HISTORIC AND DESIGN REVIEW COMMISSION

HDRC CASE NO: 2024-194
ADDRESS: 421 N MEDINA
LEGAL DESCRIPTION: NCB 249 BLK 78 LOT 11, 12 & N 27.92 FT OF 10, LOT NE 99.37 FT OF THE W 1-2 OF BLK 249
ZONING: IDZ-2, HS
CITY COUNCIL DIST.: 5
LANDMARK: Individual Landmark
APPLICANT: Jennifer Gonzalez
OWNER: 421 Medina LLC
TYPE OF WORK: Historic Tax Certification
APPLICATION RECEIVED: May 28, 2024
60-DAY REVIEW: July 21, 2024
CASE MANAGER: Rachel Rettaliata

The applicant is requesting Historic Tax Certification for the property at 421 N Medina.

SP-1

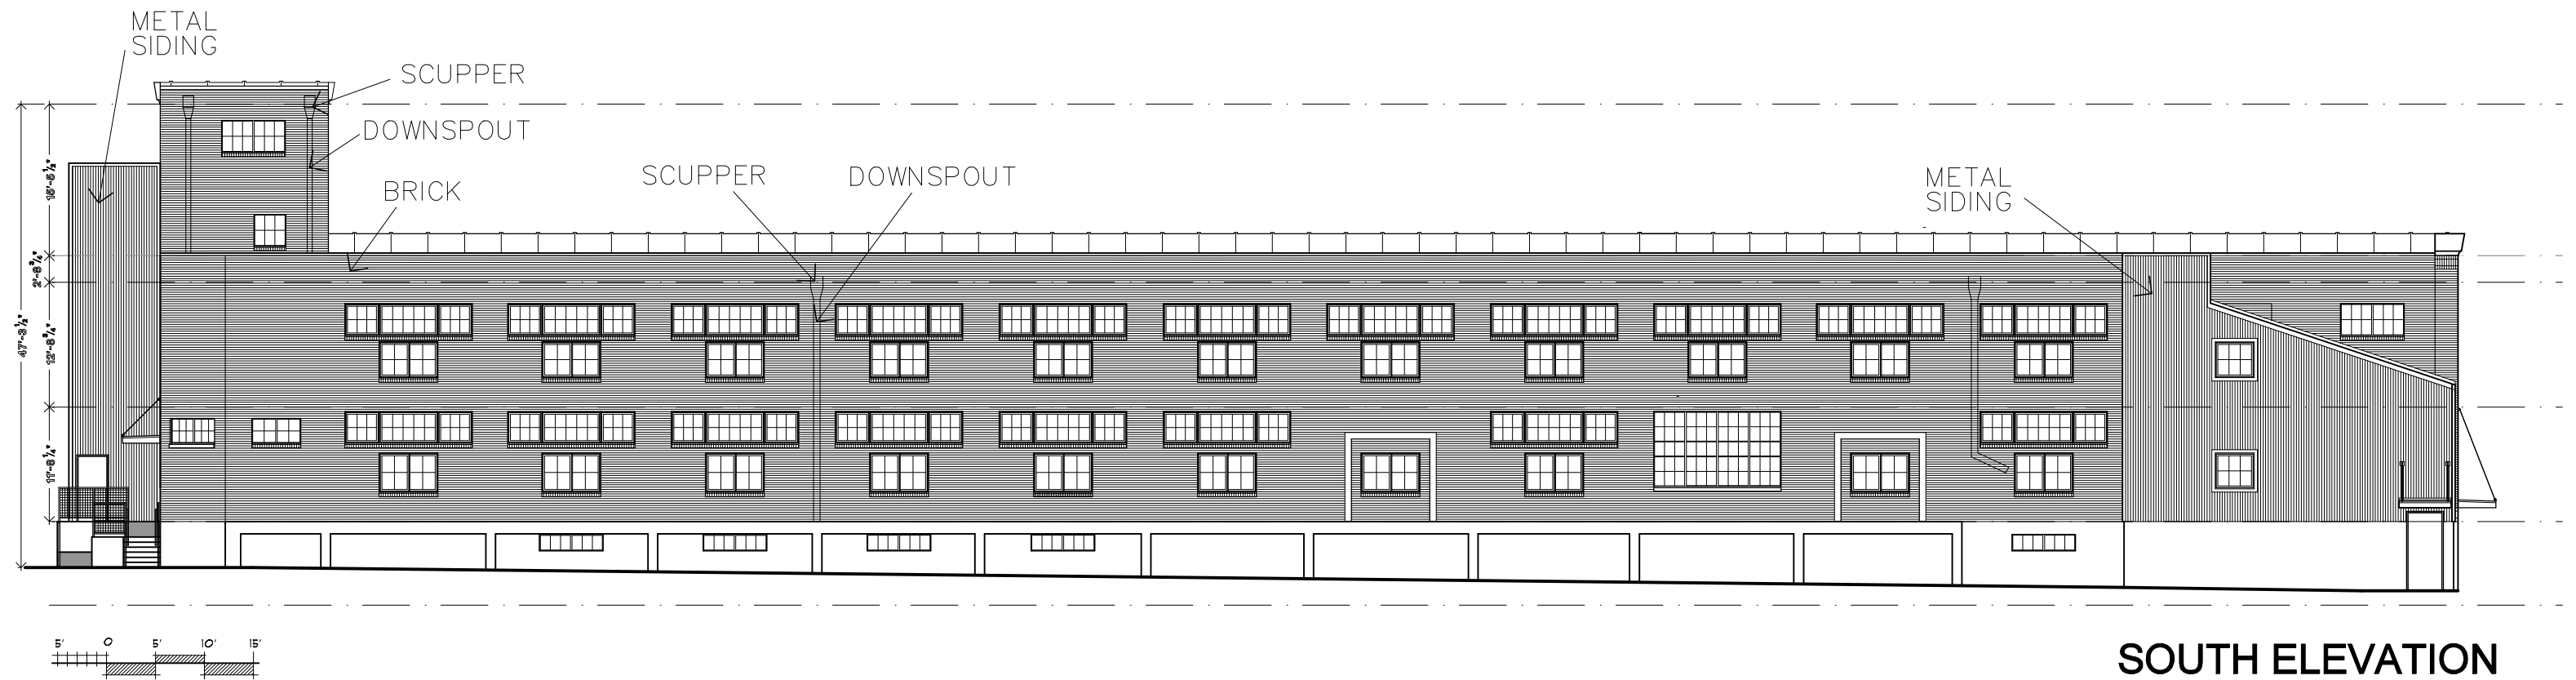
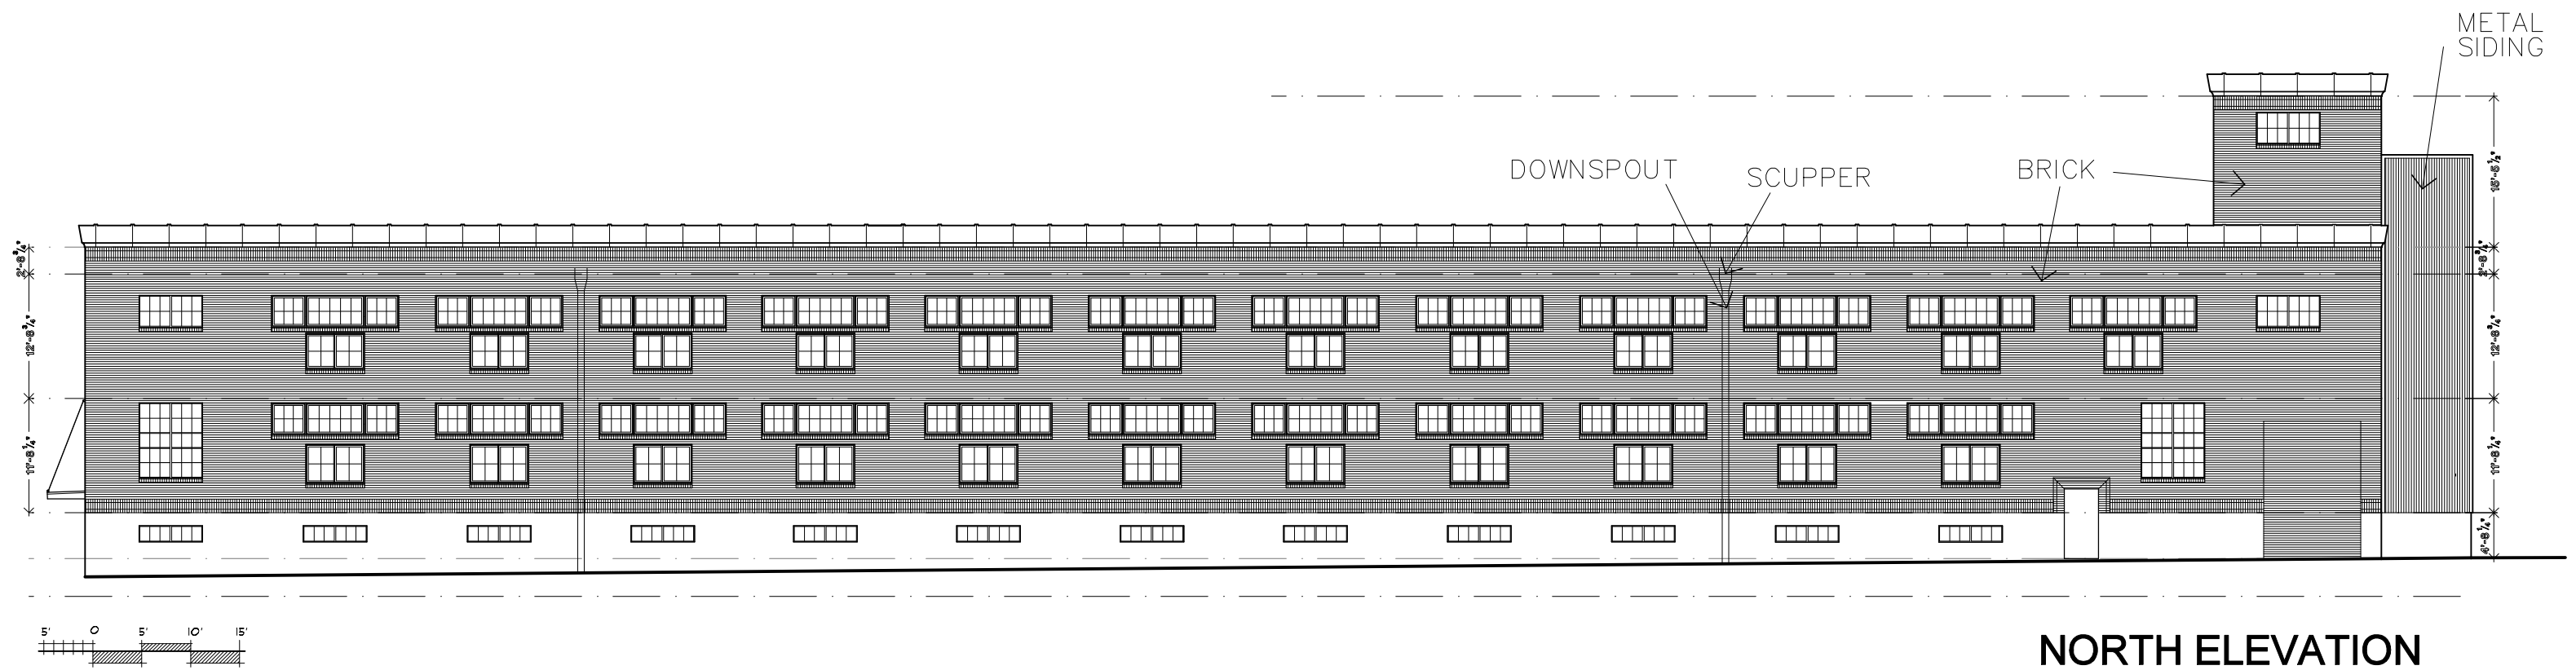
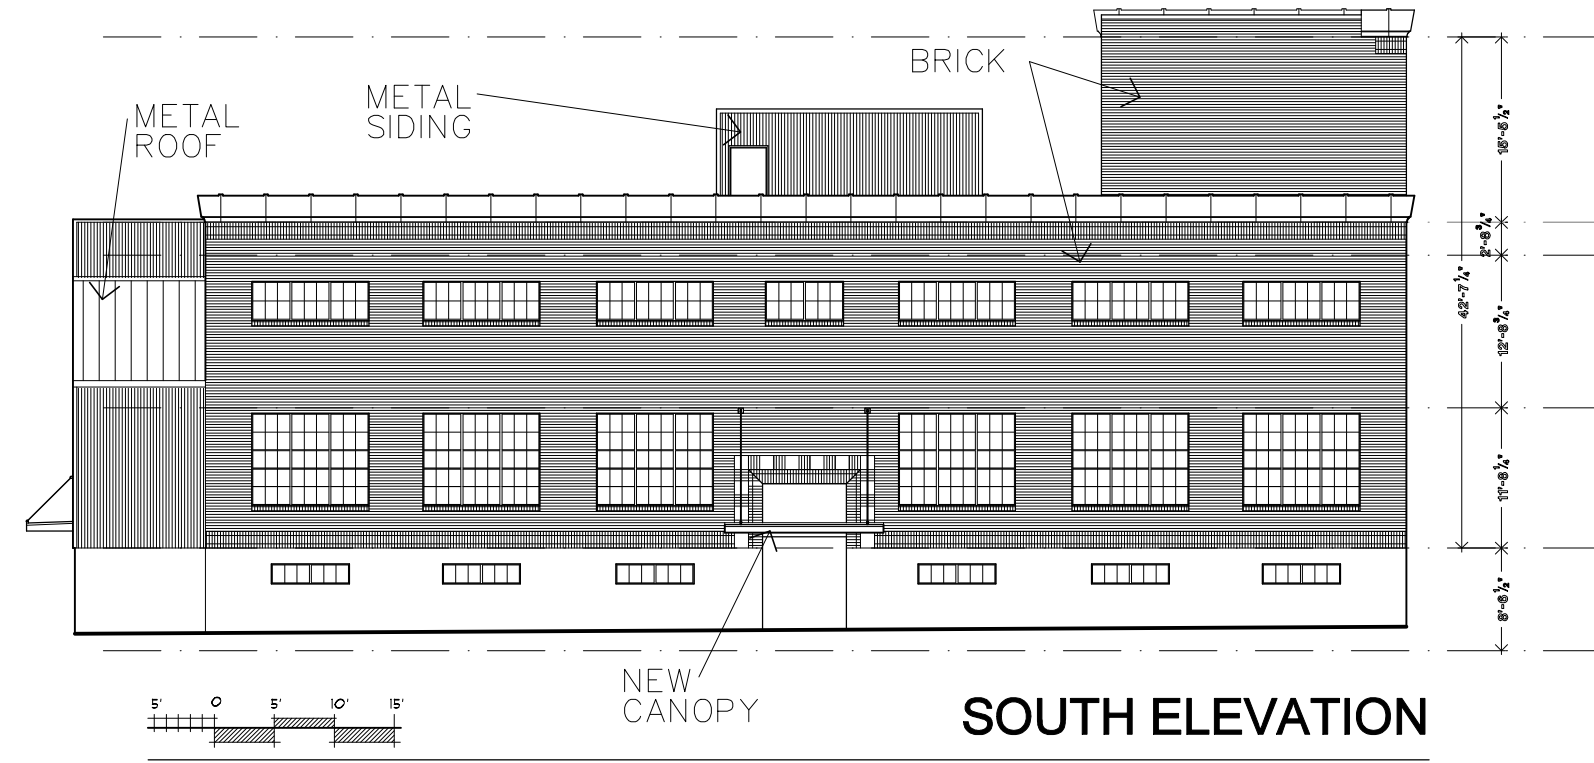
h. CIRCULATION TOWER ADDITIONS – The applicant has proposed to construct two circulation towers, one on the south façade and one on the west façade. The proposed circulation towers will include both stairs and elevators, and the tower addition on the west façade (rear façade) will feature a ramp element at ground level. The applicant has proposed to clad both towers with metal siding. Generally, staff finds the construction of both circulation towers to be appropriate. The applicant has noted that the circulation tower on the south façade will be recessed from the corner brick detailing. Staff finds this to be appropriate. Staff finds that final materials specifications for the proposed metal siding should be submitted to OHP staff for review and approval.

- ii. That the circulation tower on the south façade be removed from the corner to expose the original corner brick detail.
7. Staff recommends approval of item #7, the parking lot expansion and site work based on finding i, with the stipulation that final parking lot details and design documents, including landscaping and fencing elements are to be submitted to OHP staff for review and approval.
